RE: **Response to Peer Review Comments**
The Village at Sudbury Station – 30 Hudson Road Sudbury, Massachusetts

MDM Transportation Consultants, Inc. (MDM) has prepared the following response to transportation-related peer review comments for the above-referenced project, as issued in a letter by the City's peer review consultant, Vanasse and Associates, Inc. (VAI), dated March 3, 2016. To facilitate review, specific comments are paraphrased with corresponding responses. Where appropriate, responses provided with input from the Applicant's design team are noted and include Sullivan Connors Associates (SCA) and Winn Residential (Winn).

Exhibit 2
Intersection Sight Distance
Hudson Road

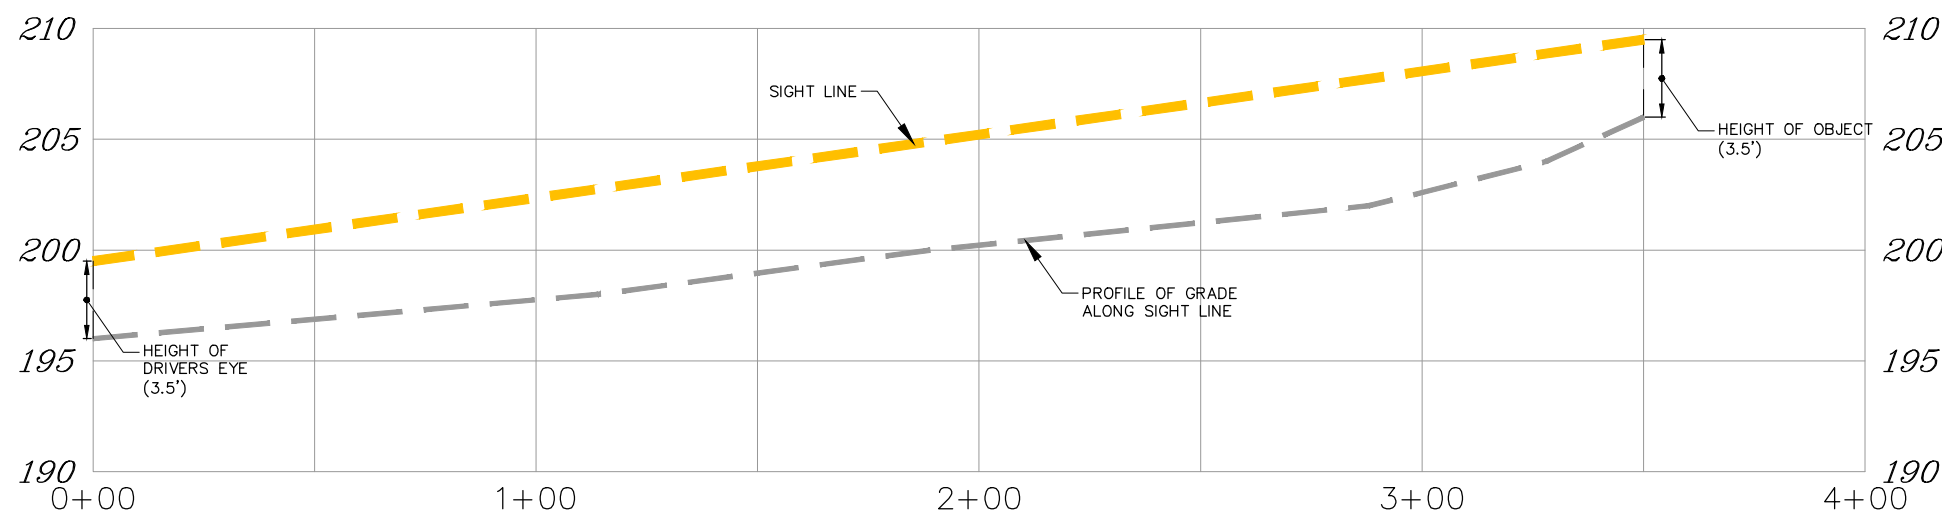
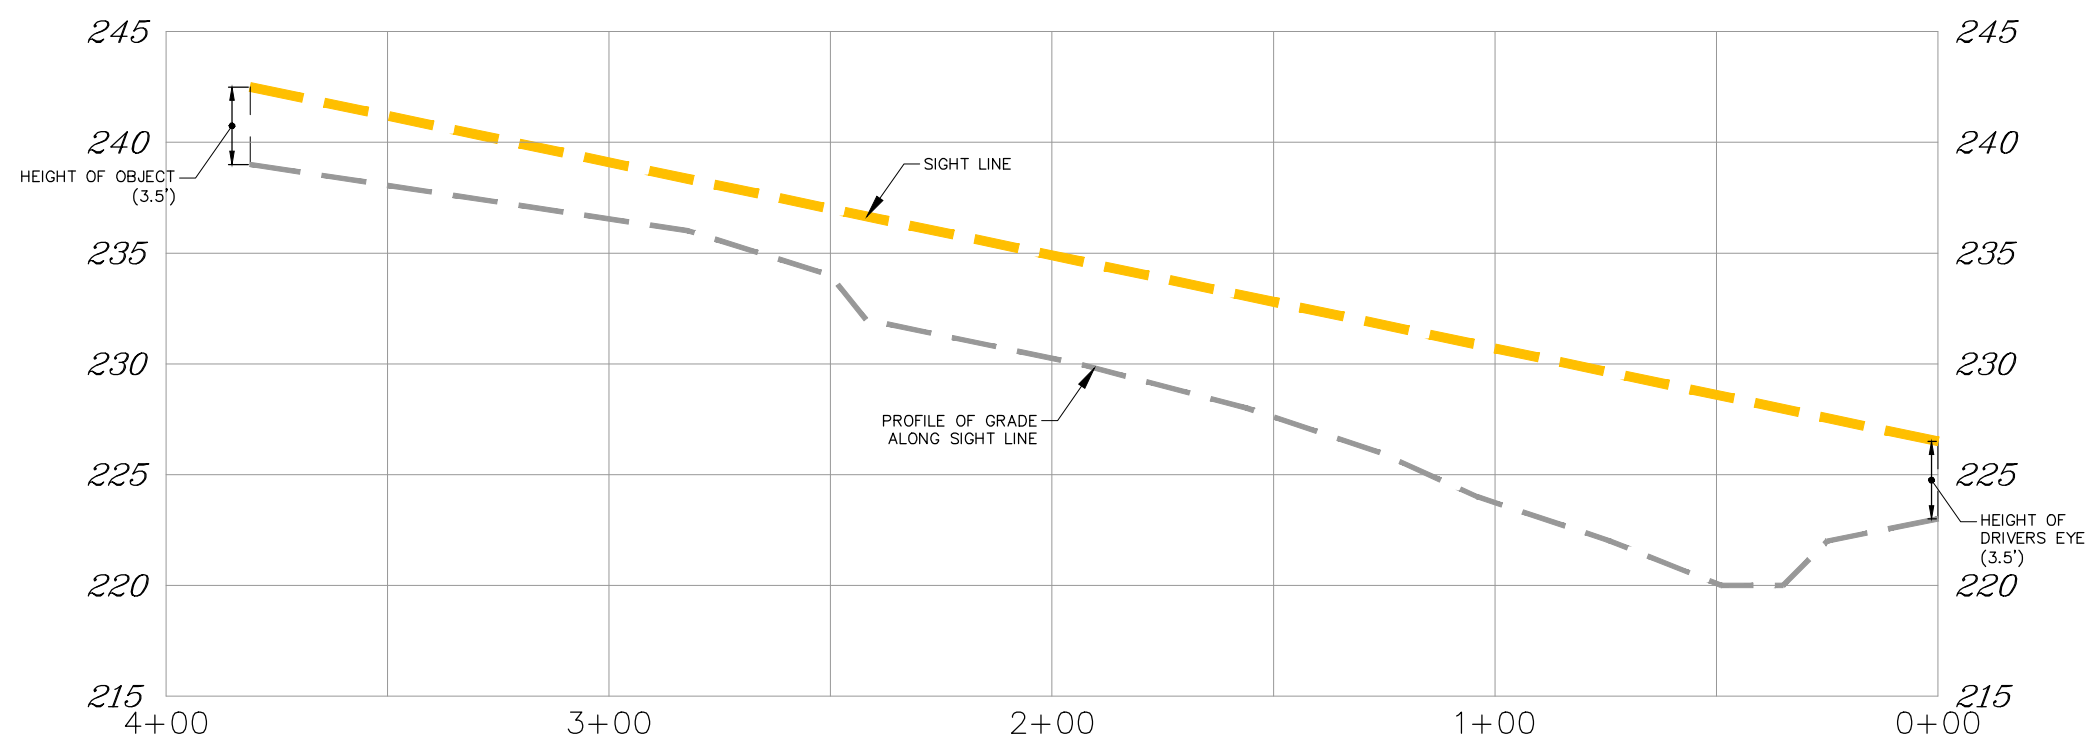
The Applicant's engineer should provide a sight distance plan illustrating the required sight lines to and from the Project site roadway intersections in both plan and profile view that illustrate the existing and proposed surface elevations and any obstructions that need to be removed within the sight triangle areas.

These plans will allow for an understanding of the location(s) and extent of any regrading of land that may be necessary to attain the required sight lines.

Response: Site Plans prepared by SCA as updated through March 14, 2016 include sight line triangle areas at each of the driveways serving the property with an associated note that reads *"Signs, landscaping and other features located within the sight triangle areas shall be designed, installed and maintained so as not to exceed 2-feet in height. Snow windrows located within the sight triangle areas that exceed 2-feet in height or that would otherwise inhibit sight lines shall be promptly removed."* Additionally, MDM has prepared sight line diagrams in plan and profile that confirm applicable sight line criteria will be met at both driveway locations as follows:

- **Exhibit 2:** *Intersection Sight Distance, Hudson Road.* This diagram depicts the sight line looking east from the Site driveway (vehicles approaching from the east) and confirms that once removal of trees and other vegetation is conducted by the Applicant along this sight line, no grading is necessary to achieve the necessary sight lines at the proposed driveway. MDM notes that grades looking right from the Site driveway (vehicles approaching from the west) are at or below the elevation of a vehicle stopped in the driveway, hence also does not require any regrading to achieve necessary sight lines as reported in the December 2015 TIAS.

- **Exhibit 3:** *Intersection Sight Distance, Concord Road.* This diagram depicts the sight line looking south from Peter's Way (vehicles approaching from the south) and confirms that no grading is necessary to achieve the necessary sight lines at the proposed driveway. MDM notes that grades looking left from Peter's Way (vehicles approaching from the north) follow the existing sloped (southbound downgrade) of Concord Road, hence also does not require any regrading to achieve necessary sight lines as reported in the December 2015 TIAS.
